HORSHAM DISTRICT COUNCIL CONSULTATION

TO:	Horsham District Council – Planning Dept
LOCATION:	Chanctonbury Nurseries Rectory Lane Ashington
DESCRIPTION:	Application for approval of details reserved by conditions 7 & 14 to approved application DC/22/0372
REFERENCE:	DISC/24/0129 / DISC/24/0135
RECOMMENDATION:	More Information/ Advice

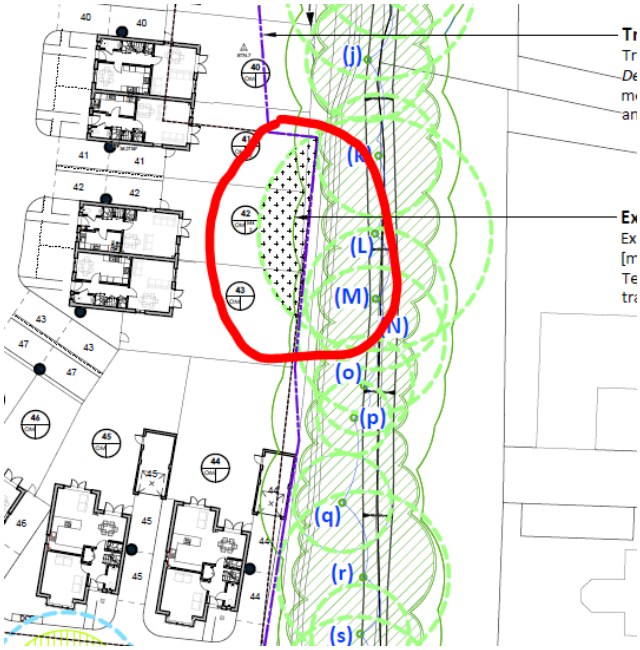
The proposed tree protection measures within the AMS and TPP documents are in accordance with BS 5837, however, where the RPA of tree I of TL O8 encroaches on the garden area of units 41, 42, and 43 the tree protection fencing (TPF) does not cover the enter RPA tree. I have been unable to identify any justification as to why this is the case, and the TPF needs to be moved to cover the entire RPA of tree I of TL O8.

DRAINAGE LAYOUT
SHEET 3 OF 3

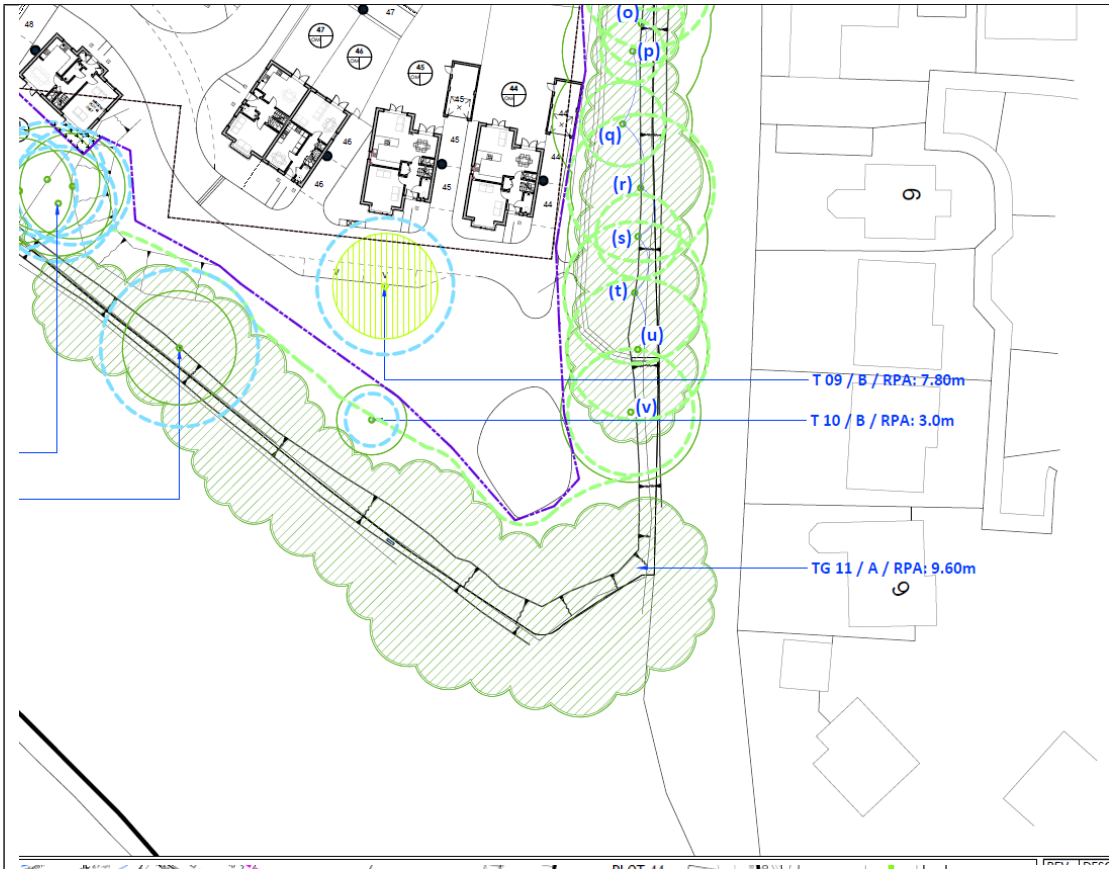
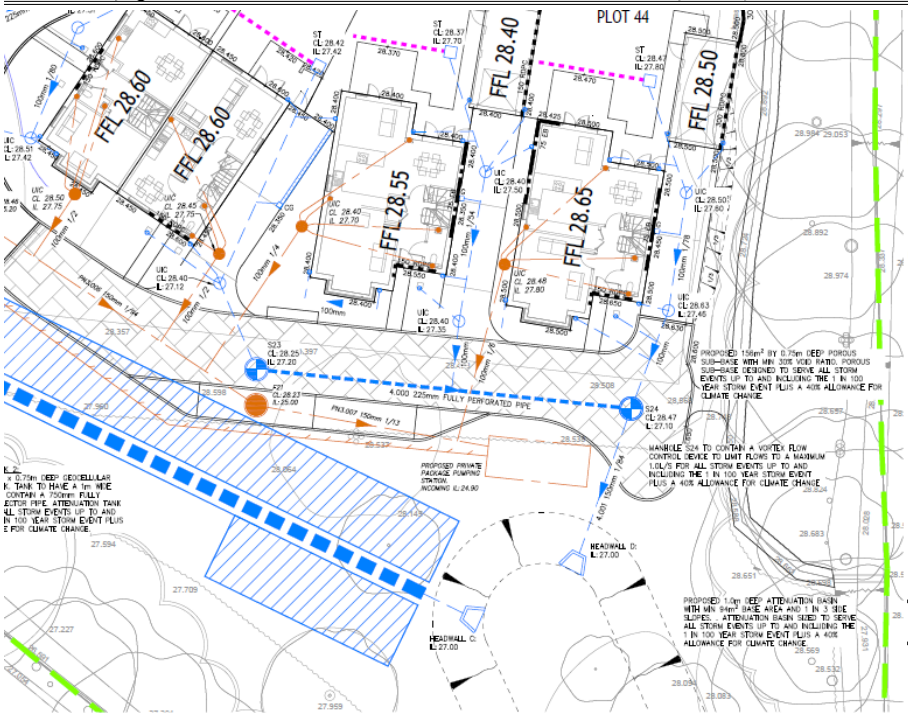
Another observation with drainage lay out plans provide with DISC/24/0129, is with the location of the suds basin in the southeast corner of the site. when you compared the drainage lay out plans against the TPP it Is not clear if this aspect of the development would require excavations to occur within the RPA of a retied tree as the corner of the drainage lay out plan has been cut off; confirmation is needed to ascertain the full impact of the SUDS on the retained trees in this area. If issues are identified in order to make a fair assessment of the impact the AMS should be amended and set out exactly how the works would be completed in a way that would insure the successful retention of the affected trees, or consideration should be given to moving the SUDS.
